OPTION #A--STEPPING MULTIPLE SLOPES

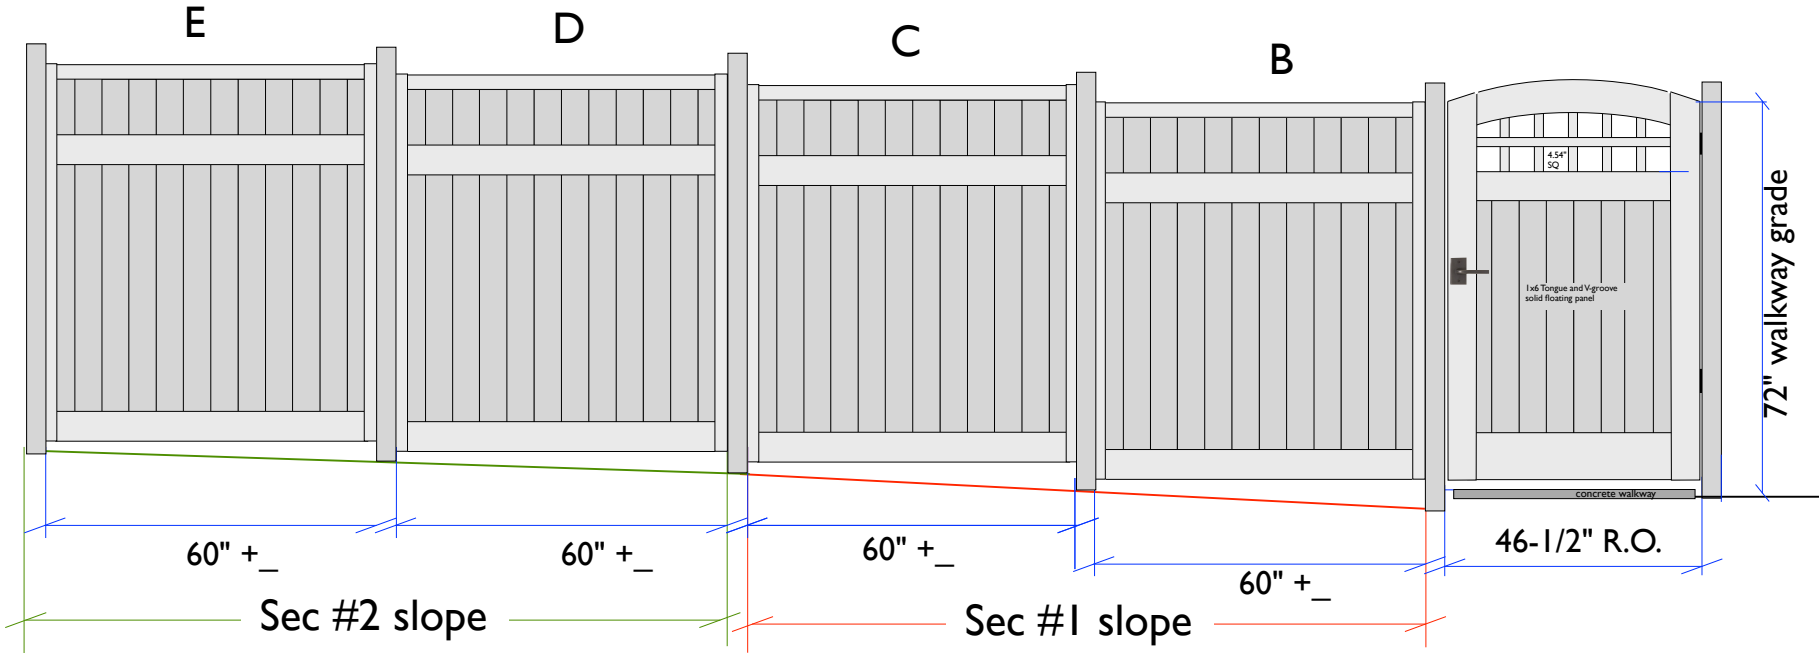
Sec. #1 slope appears to be more dramatic, requiring panels B & C to step up more so. Feathering the grade up along the low point of each panel is suggested, if possible.

Sec #2 slope appears to be more gradual, allowing Panels D & E to be either level across the top, or step to a slighter degree. Suggest feathering the grade here as well.
